REMARKS

Status of Prosecution

Following review of Applicant's Amended Appeal Brief by an Appeal Conference panel, the file was returned to the Examiner with instructions. The Examiner thereafter entered a new non-final office action on March 22, 2005 that reopened prosecution and advanced new arguments for rejection of claims 1-22 ("Reopened Office Action"). This Reply to Office Action is in response to the Reopened Office Action.

FIGURES 4-5 OF MURRAY PATENT

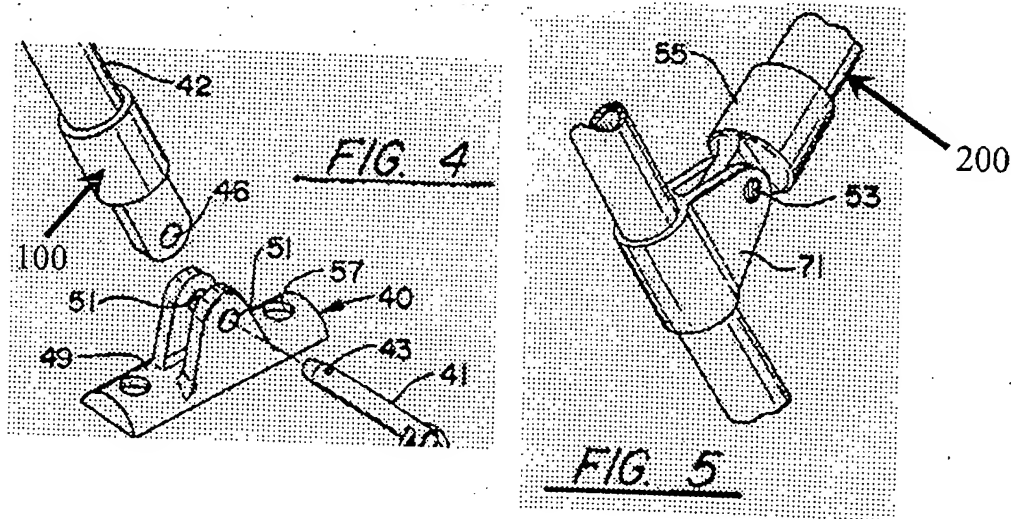
The apparatus of the Murray Patent is not universally adjustable. As is evident from the marked-up figures shown by the Examiner on page 4 of the Reopened Office Action, and reproduced on page 14 of this Reply, the component that the Examiner labeled “tub 100” allows leg 42 to be positionable in one plane only. Together, components 42 and 100 may rotate only in

one plane around the axis formed when quick release pin 41 is inserted through apertures 52 (see reproduced Figures 4-5 of the Murray Patent, and column 3, lines 58-64).

Beginning on page 8 of the Reopened Office Action the Examiner includes a number of comments about the arguments advanced by Applicant in Appellant's Amended Appeal Brief. For example, the Examiner states that Applicant "does not fully appreciate that figures 4 and 5 show separate sections of the assembly of figure 1." The term "figure 1" apparently refers to Figure 1 of the Murray Patent. The Examiner goes on to state: "Figures 1, 4 and 5, as depicted together above, show that element 100, while similar in structure to element 55, is in addition to and assembled away from element 55." (Emphasis added.) Applicant respectfully disagrees.

Thus, on page 4 of the Reopened Office Action, immediately beneath marked-up Figures 4 and 5, the Examiner asserts that the Murray Patent shows "a tub...adjustably connectable to the base...[and] a plug...repositionably attachable to the tub...[and] a neck rotatably insertable in the plug..." That assertion fails when that same assertion includes the reference numerals assigned by the Examiner to the components of the Murray apparatus. For example, the Examiner attempts to reconstruct Applicant's coupler by stating that component 100 is a "tub," and that component 42 is a "plug" repositionably attachable to the tub. Component 42 is, however, not reasonably comparable to the variably positionable plug 72 of Applicant's coupler. Indeed, component 42 is described in the Murray Patent as one of the "legs" of the U-shaped structure that supports the canopy: see Murray Patent, column 3, lines 8-11, lines 33-38, lines 55-60, and column 4, lines 1-7. If comparable to any elements of Applicant's coupler, leg 42 would be shaft 110, shown in Applicant's Figure 5 – which is connectable to neck 74, not tub 70.

1. The marked-up figures included by the Examiner on page 4 confirm that the underside of base 40 is flat. The Examiner concedes that the underside of base 40 is a “flat planar surface.” See Reopened Office Action, page 4. A flat planar surface is not designed for mounting on a curved surface absent additional means for mounting. Nothing in the Murray Patent suggests or teaches that the Murray apparatus is intended to be mountable on a curved surface, and the Examiner points to none. Were the Murray apparatus mounted on a curved surface, it would not be mounted securely, and likely would tear loose from the hull of a craft because none of the other components attached to the Murray apparatus are variably positionable.

On further reflection, the Examiner will appreciate that element 100 and element 55 are identical, not similar, in structure; that the differences in structure occur in connection with the

configuration of the substrate on which component 100 and component 55 are mounted. Thus, component 100 is mounted on base 49 having a flat planar surface (see Reopened Office Action, page 4), whereas component 55 is mounted on a tube formed with T-fitting slides 71. Again, the structural difference resides in the different substrates, not in component 100 and component 55. What is more germane, however, is the fact that under no interpretation of the components of the Murray apparatus can either Figure 4 or Figure 5 be construed to show the tub and plug of Applicant's apparatus, an argument made clear in subparagraph C. below.

FIGURES 5-8B OF APPLICATION

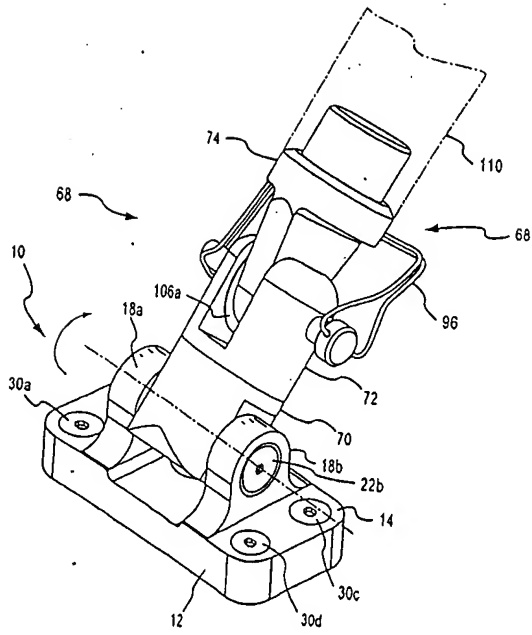
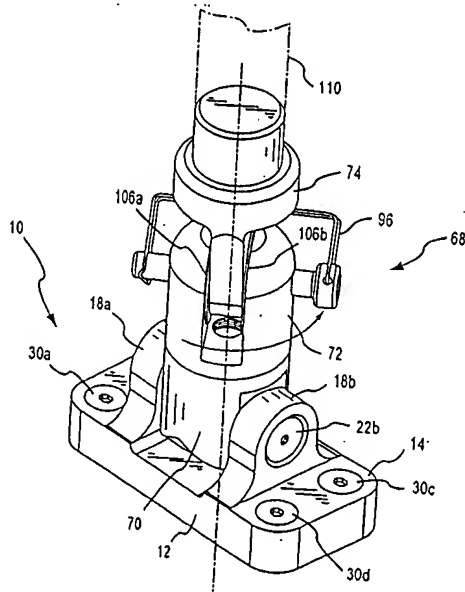
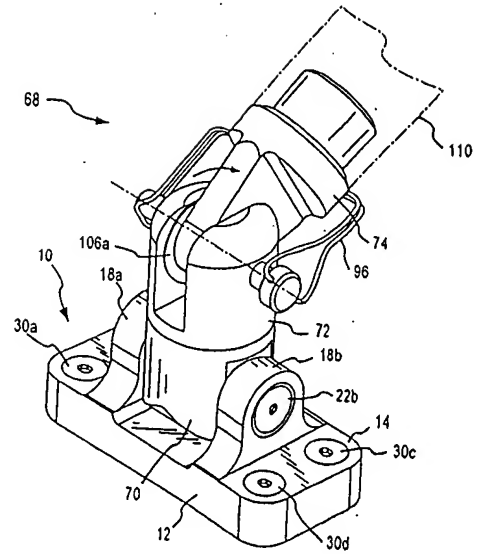
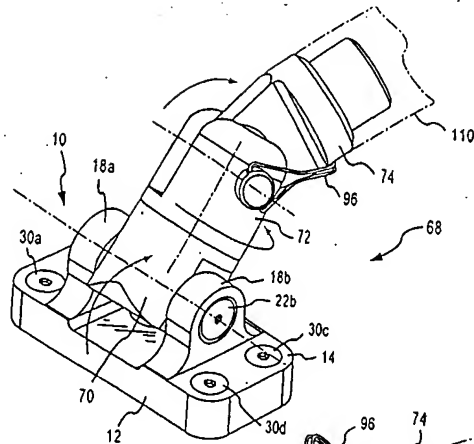
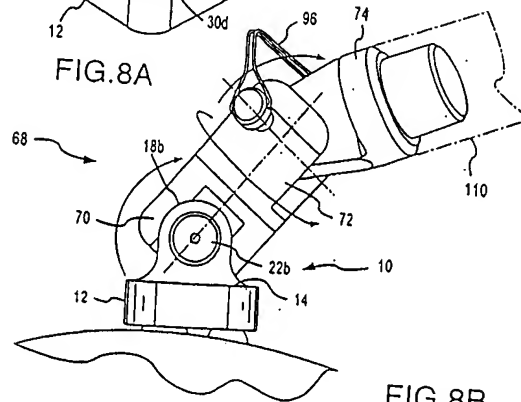
Applicant's coupler, however, is not limited to restricted rotation in a single plane. Rather, Applicant's coupler is variably positionable and universally adjustable for mounting on any shape of hull of a craft, including a curved surface. This unique feature of Applicant's coupler is emphasized and demonstrated graphically by Applicant's drawing Figures 5-8B, reproduced on page 15 of this document.

Thus, as shown in Figures 5 through 8B, the semi-circular arrows demonstrate that the components of Applicant's coupler are positionable not merely in one plane like the Murray apparatus, but in a wide variety of positions, in a wide range of varying planes, along an array of combinations and permutations of x-, y-, and z-axes.

For Example, Figure 6, however, begins to demonstrate the mechanical departure of the coupler from the Murray apparatus. The semi-circular arrow shown on plug 72 of coupler 10 shows yet another of the variable positions of the coupler by showing that because of the unique use of plug 72 in combination and mechanical cooperation with neck 74 and tub 70, components of coupler 10 may also and simultaneously rotate around a y-axis. Figure 7 shows that a segmented portion of coupler 10, namely neck 74, may rotate around yet another z-axis. As indicated in the "Brief Description of the Drawing," Figure 8A shows that tub 70 may rotate around the axis formed by first threaded bolts 22a,b in opposing yokes 18a,b, while at the same time plug 72 may rotate in relationship to tub 70, while at the same time neck 74 may be variably positioned in yet another plane or direction -- all of which is shown again for emphasis from an alternative perspective in Figure 8B, which also demonstrates graphically that the flat bottomed base 12 is securely fastenable to a curved surface through the use of the ball washer assemblies 40.
